PLANNED UNIT DEVELOPMENT STAFF REPORT**Date: July 10, 2003****DEVELOPMENT NAME**

Mulekar Subdivision

LOCATION3221 Spring Hill Avenue
(South side of Spring Hill Avenue, 200'± East of Durant Street)**PRESENT ZONING**

SITE PLAN

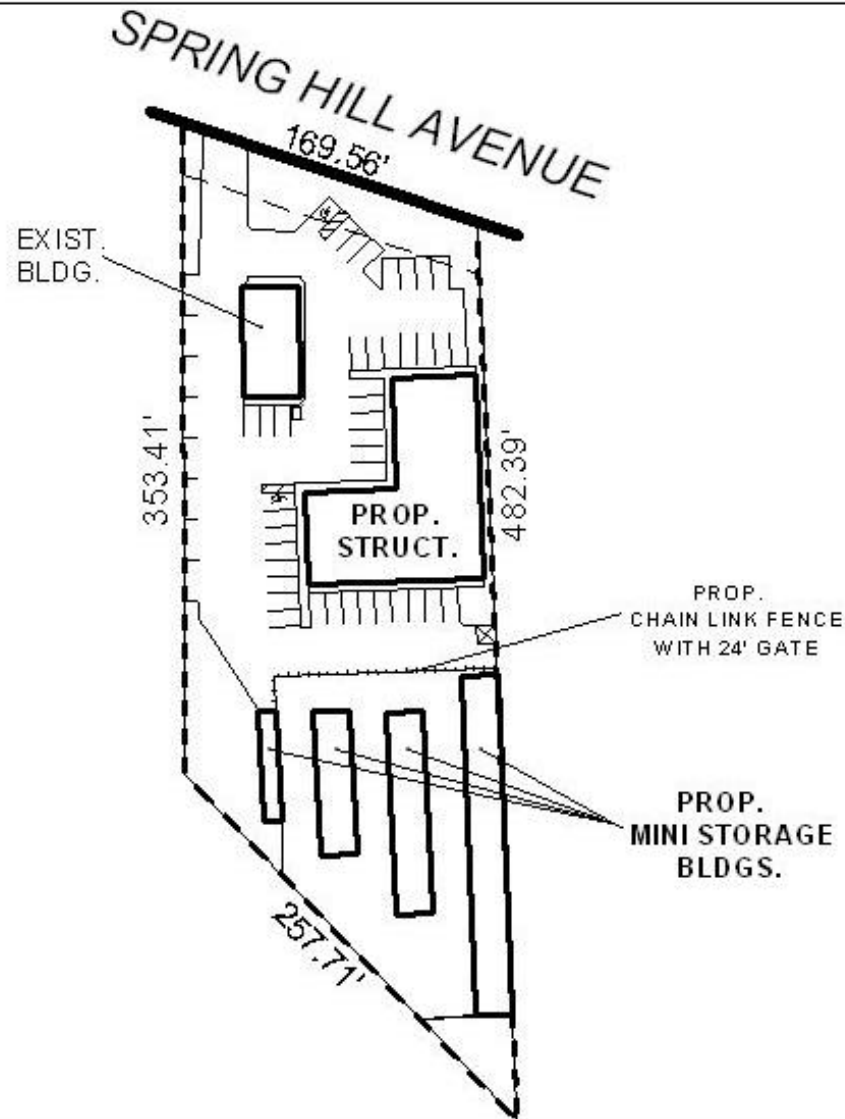
There are minor discrepancies on the plan with regard to calculations for required parking versus parking provided, and for the number of trees required versus the number of trees provided or credits claimed.

The calculations indicate that 32 parking spaces are required and 33 are provided. However, a count of the parking spaces illustrated on the plan totaled 47 spaces, which is 46% more than the number of spaces required. The plan indicates eight parallel parking spaces along the West property line and adjacent to a circulation aisle. As these spaces are excess and could impede circulation (especially as the aisle is barely 24' wide for two-way traffic), the elimination of these spaces should have little or no impact on the development.

Also, the calculations for tree requirements indicate 10 credits for existing trees. However, only two existing trees are noted as to size and species for a total of three credits. Therefore, additional information would be required to determine the exact number of tree credits and tree plantings required.

Another discrepancy is that the plan denotes one of the mini-storage buildings as 10' x 60' in text, and 10' x 50' on the dimension lines (building scales at 50'). While this discrepancy may seem minor, it could result in complications during the permitting process.

Based on the preceding, it is recommended that this application be approved, subject to the following conditions: 1) elimination of the parallel parking spaces along the West property line; 2) full compliance with the landscaping and tree planting requirements of the Zoning Ordinance, including but not limited to accurate depiction and description of trees claimed for credit, and existing trees to be trimmed or removed, to be approved by Urban Forestry; 3) accurate dimensions of all buildings be reflected on the plan; and 4) full compliance with all municipal codes and ordinances.
